**RESOLUTION SETTING HEARING ON REQUEST FROM CITY OF DES MOINES FOR A
CERTIFICATE OF APPROPRIATENESS FOR WOODLAND CEMETARY AT 2019
WOODLAND AVENUE**

CITY OF DES MOINES LANDMARK REVIEW BOARD
STAFF REPORT AND RECOMMENDATION
 Tuesday, September 6, 2022

CAHP-2022-000044

Location: 2019 Woodland Avenue.

ROAD 2 - RECOMMENDATION: TO BE PRESERVED

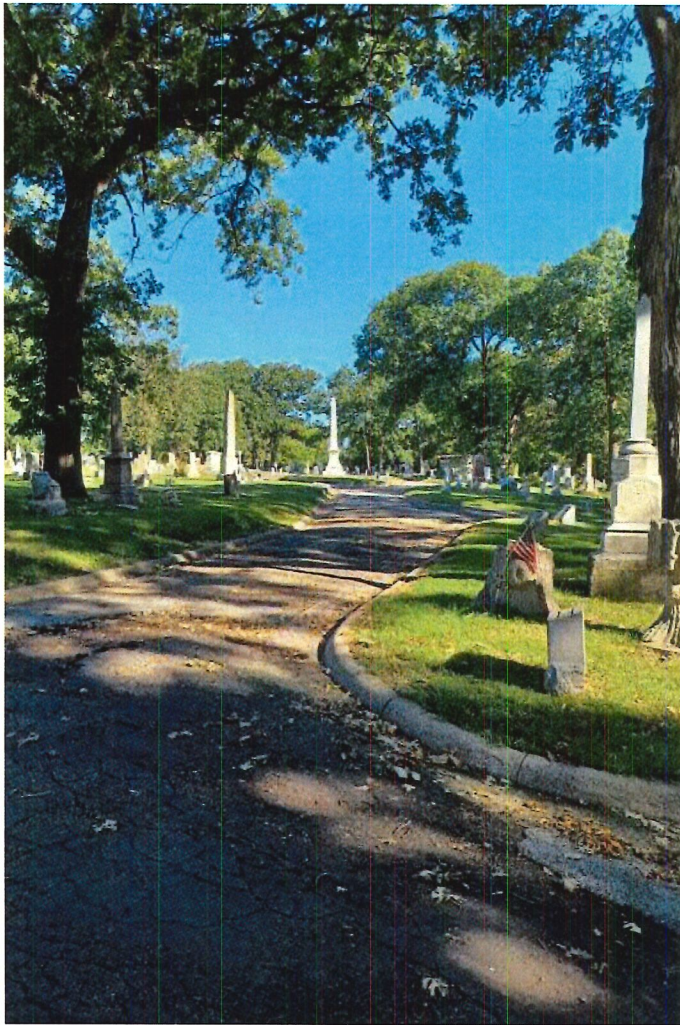
ROAD 2
RECOMMENDATON: TO BE PRESERVED

ROAD 4 - RECOMMENDATION: TO BE PRESERVED

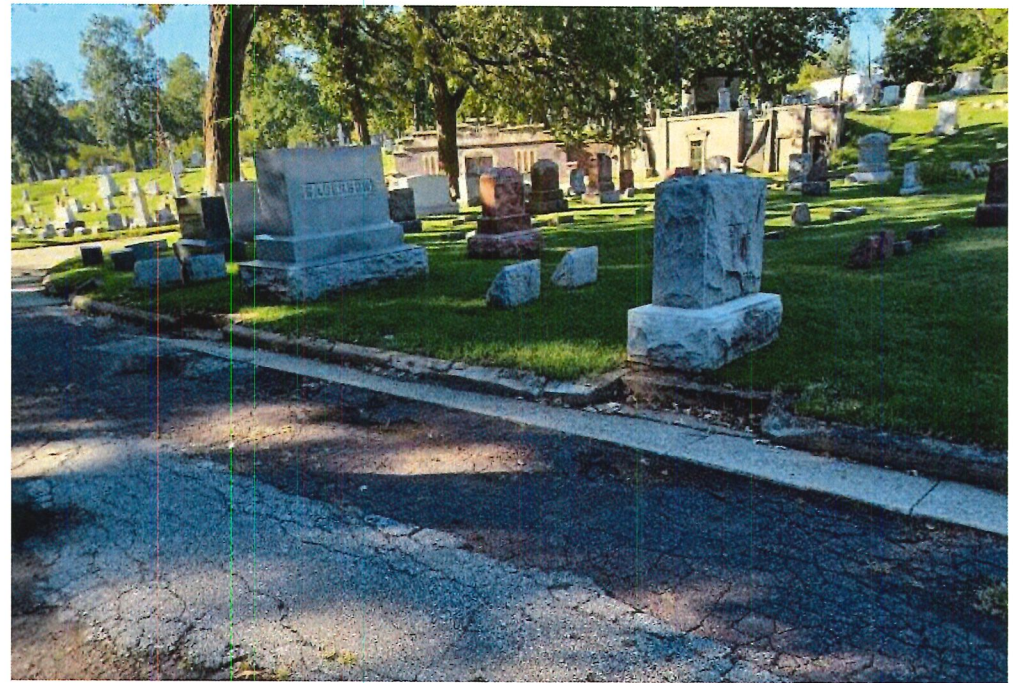
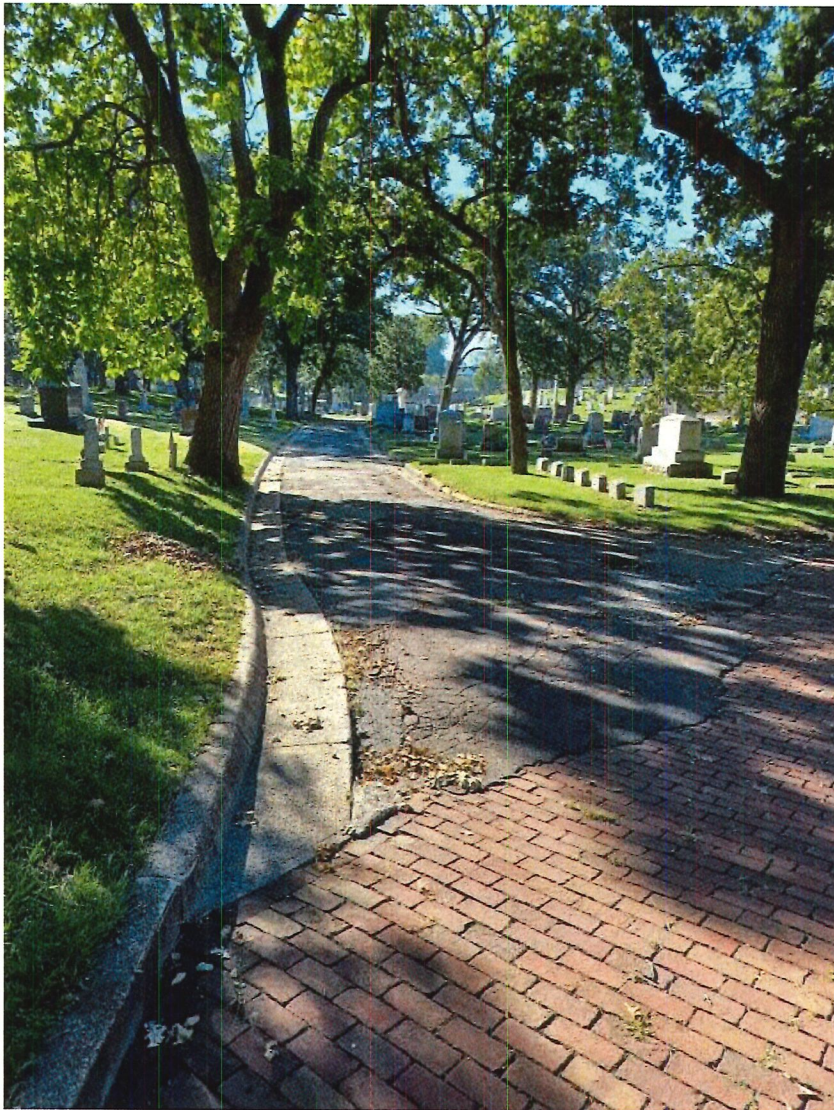
ROAD 4
RECOMMENDATON: TO BE PRESERVED

ROAD 5 - RECOMMENDATION: TO BE PRESERVED

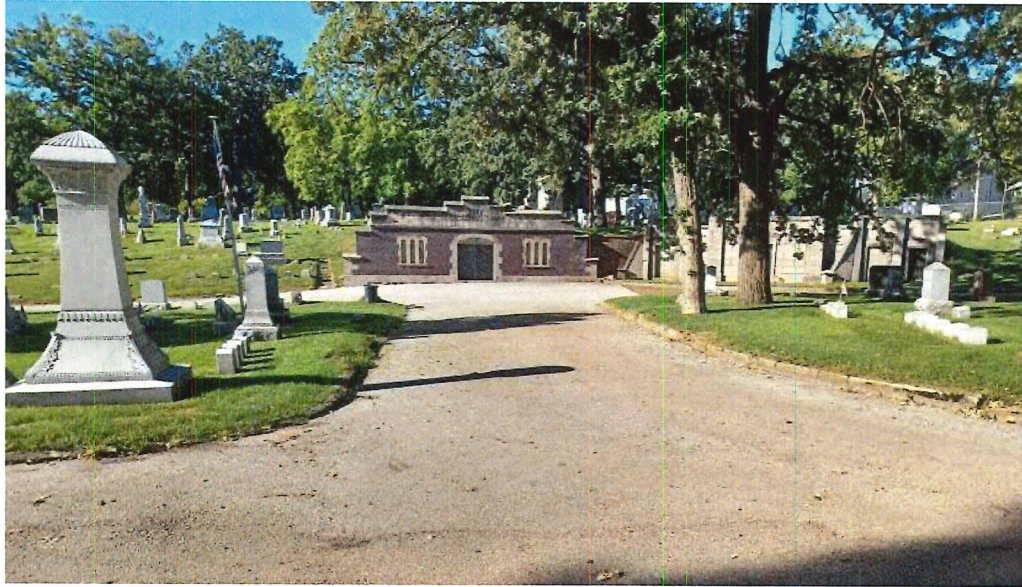
ROAD 5
RECOMMENDATION: TO BE PRESERVED

ROAD 10 - RECOMMENDATION: TO BE PRESERVED

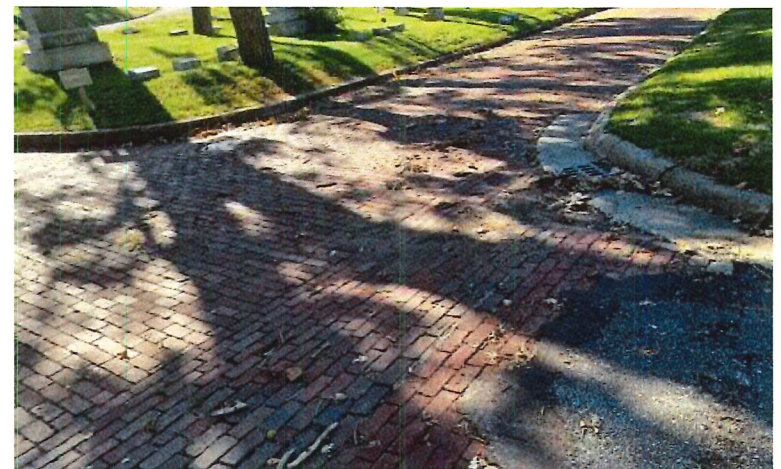
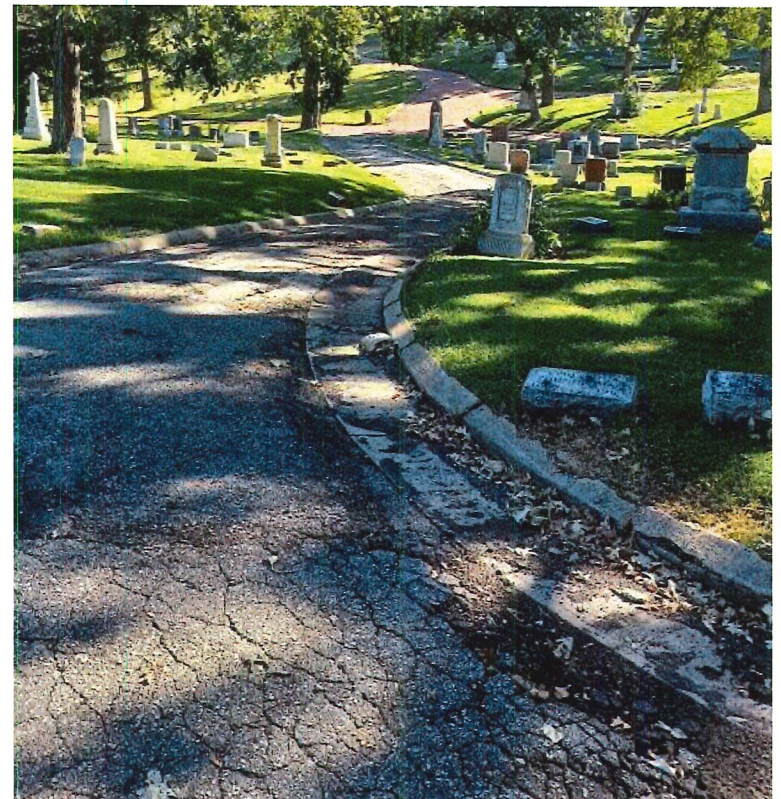
ROAD 10
RECOMMENDATION: TO BE PRESERVED

ROAD 3 - RECOMMENDATION: ROAD LIKELY ELIGIBLE FOR REMOVAL

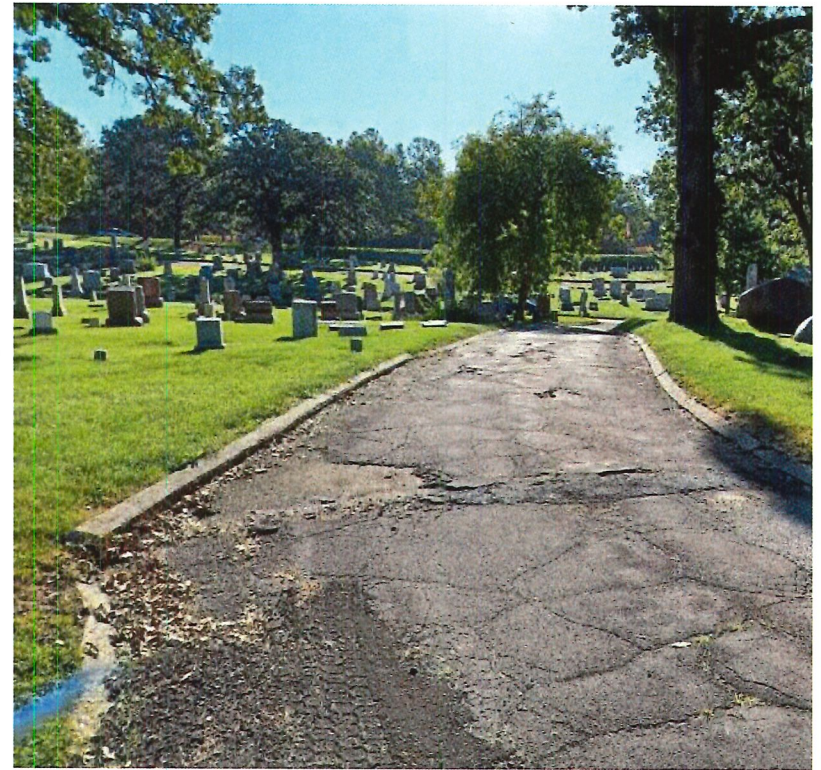
RECOMMENDATION: ROAD LIKELY ELIGIBLE FOR REMOVAL

ROAD 14 - RECOMMENDATION: ROAD LIKELY ELIGIBLE FOR REMOVAL

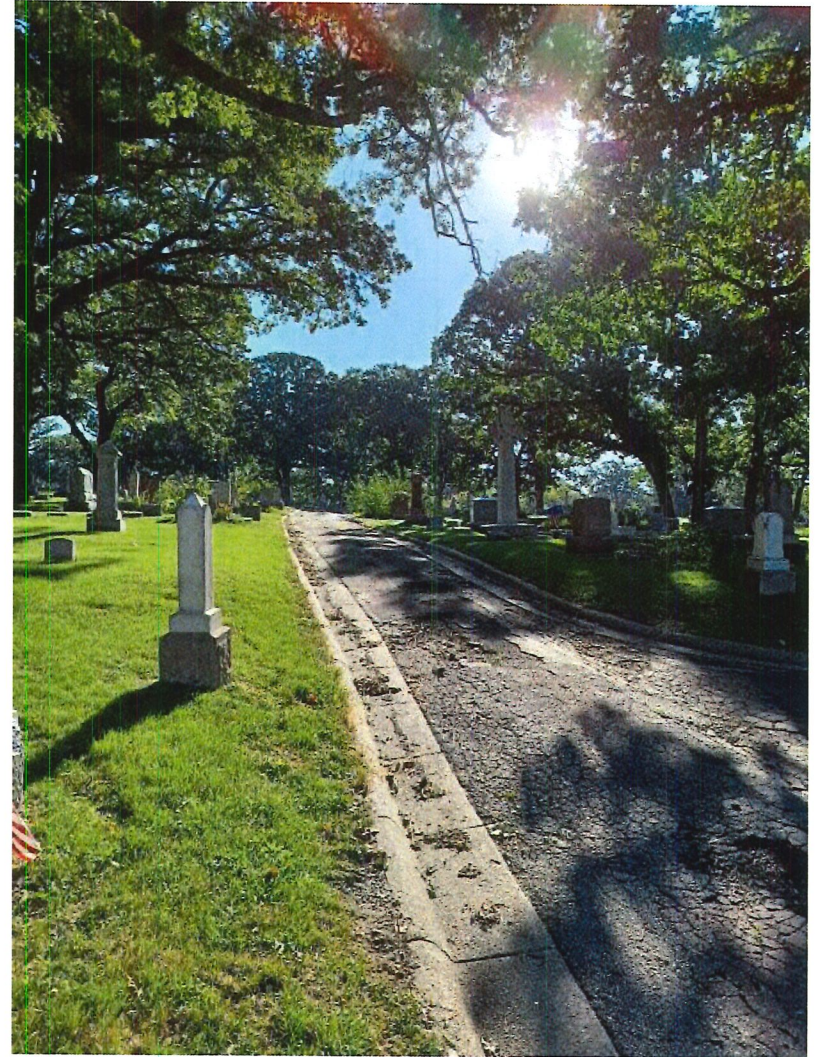
RECOMMENDATION: ROAD LIKELY ELIGIBLE FOR REMOVAL

ROADS 15 & 16 - RECOMMENDATION: ROAD LIKELY ELIGIBLE FOR REMOVAL

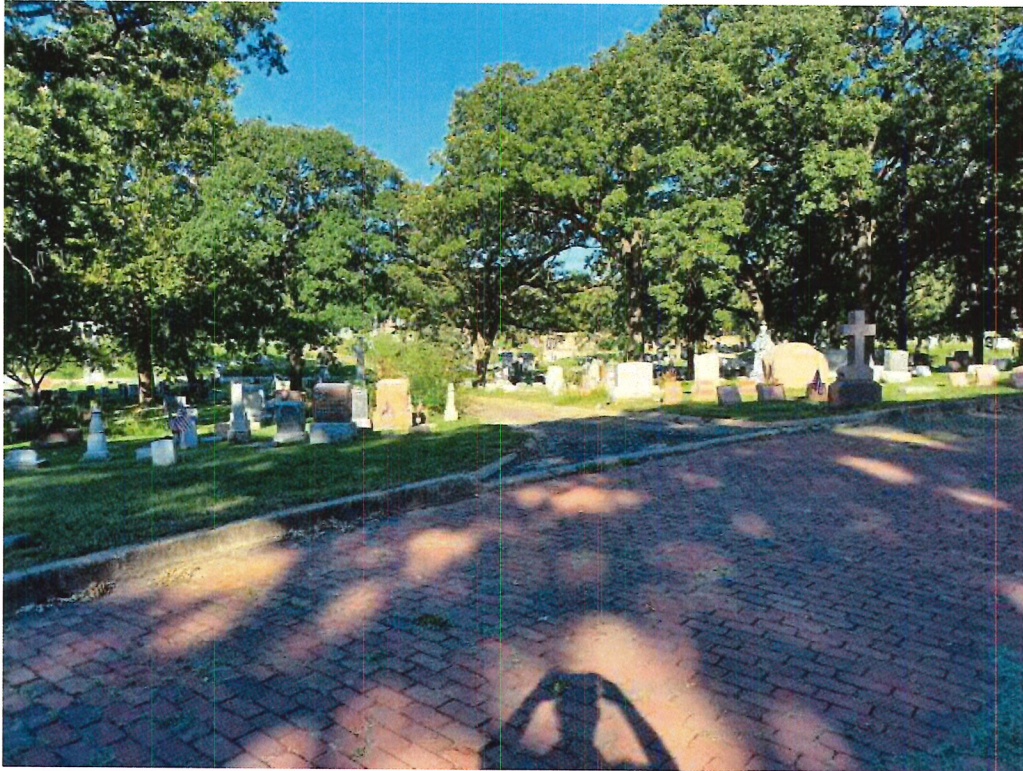
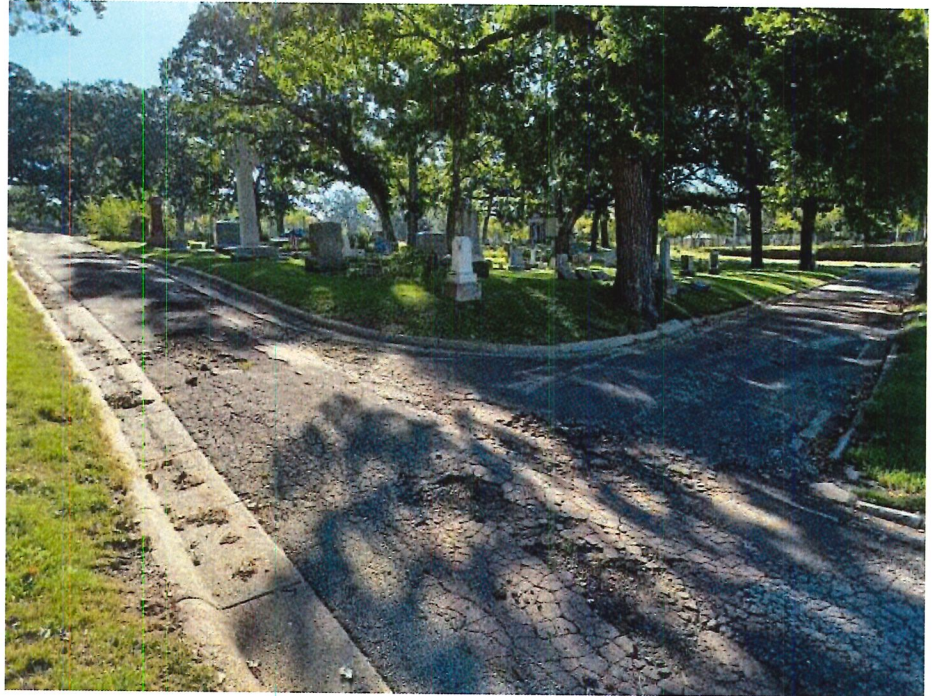
RECOMMENDATION: ROAD LIKELY ELIGIBLE FOR REMOVAL

RECOMMENDATION: ROAD LIKELY ELIGIBLE FOR REMOVAL
